GNRO-2002/00012

SUBJECT: Grand Gulf Nuclear Station, Unit 1
Docket No. 50-416
Supplement to Amendment Request Concerning
Control Rod Scram Time Testing Frequency

Response to Request for Additional Information Related to Scram Time Testing Intervals

Revised Markup of Technical Specification Bases Pages

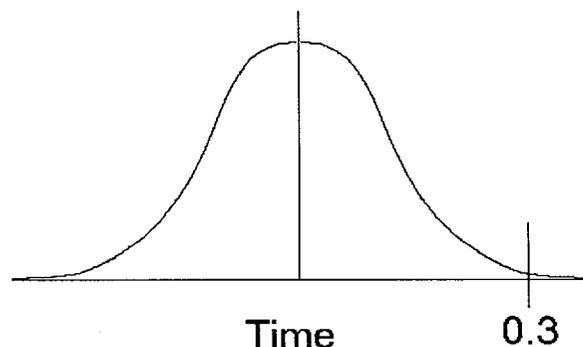
3. Reference, Page 2, last paragraph, second sentence. "An evaluation of the historic average times and standard deviation in time..."

- a) How was the standard deviation calculated?

The standard deviation of scram times was calculated by applying the standard deviation function in Excel to the measured scram times of the database population.

The relevant data is the times from notch 48 (fully withdrawn) to notch 43, since times to notch 29 (further into the core) have a much higher success rate, and since historically any test that failed at notch 29 had already failed at notch 43. The historic success rate is 0.99841 based on 12 failures per 7,524 tests in the database. This was done using straight division with no confidence level or standard deviation applied. This number does not make use of the large amount of data provided in the total test times, i.e., it doesn't recognize that most tests pass with a comfortable margin. If we think of the test times distribution as a bell curve, the vast majority lie under 0.3 seconds (the specified acceptance criteria). Relying on only the 12 points above the 0.3 seconds time is making use of only a small amount of the available information.

Our approach was to try to determine the bell curve based on the actual timing results and standard deviation.

If we had an infinite number of tests and the distribution was a perfect curve, then 3 times

the standard deviation σ would encompass 99.73% of the data. Since we have only 7,524 tests in the database, we use 3.077 times σ . The value of 3.077 is based on 100 degrees of freedom on a student t chart. It is conservative to use 100 degrees rather than $n - 1 = 7,523$ where n = number of data points.

The average test time is 0.2384 seconds with a standard deviation of 0.142 seconds. $0.2384 + 3.077 * 0.0142$ is close to, but less than 0.3 seconds. We expect only 0.27% of results to lie outside of the 3σ range evenly split between faster and slower times. So we believe only 0.135% will exceed the 0.3 second time criterion.
